## CAREMA USB CONN

## USB CONN

<b>PROJECT : ZR1/ZR2</b> <b>Quanta Computer Inc.</b>		
Size	Document Number	Rev
	<b>POWER BOARD</b>	<b>1B</b>
Date:	Monday, July 31, 2006	Sheet 0 of 1

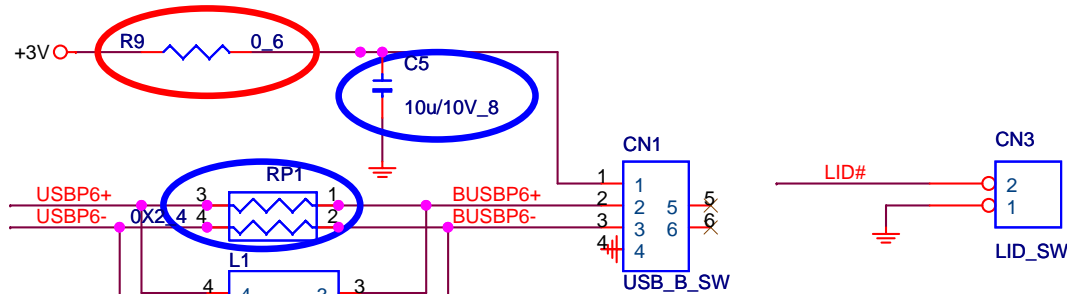
Follow ZB2 project to delete the Q1 and add R9

06/15 cost down to change the C5---CH61002ZA36

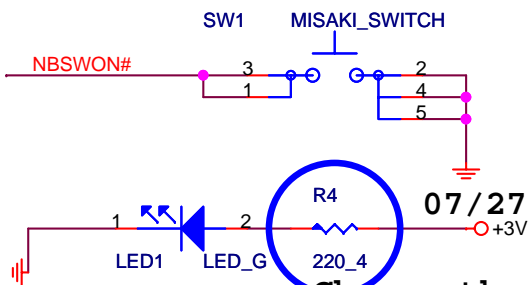
06/21 delete R2,R3,add PR1

07/27 change the R4 from 330 to 220

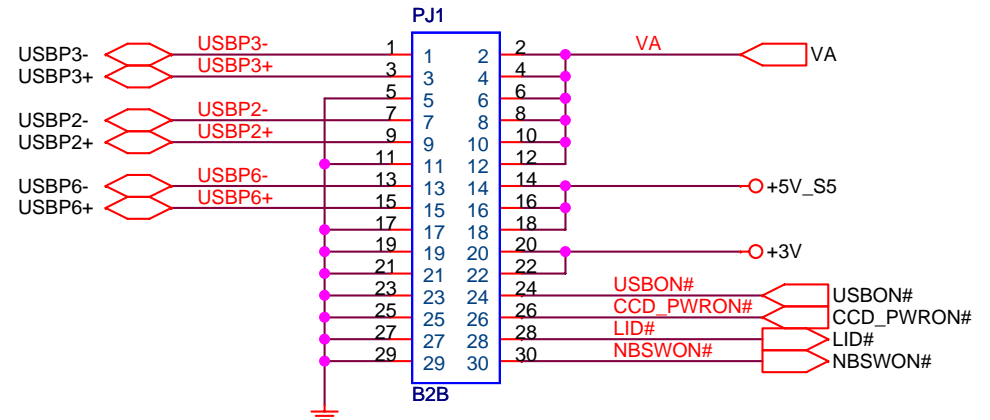
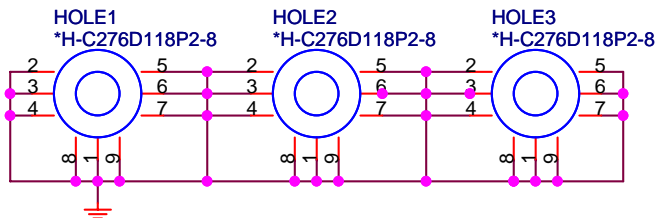
Change the bore diameter from 1.5mm to 3.0mm

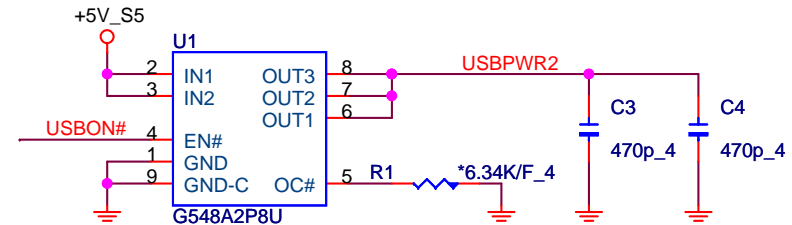
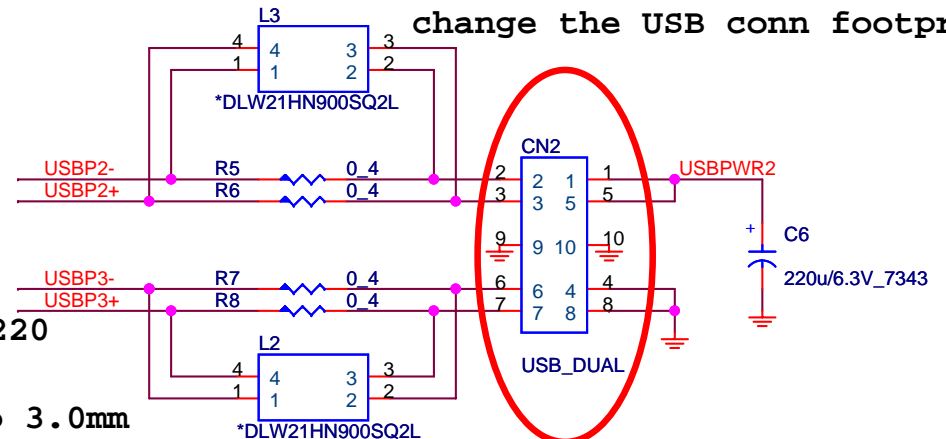
change the USB conn footprint
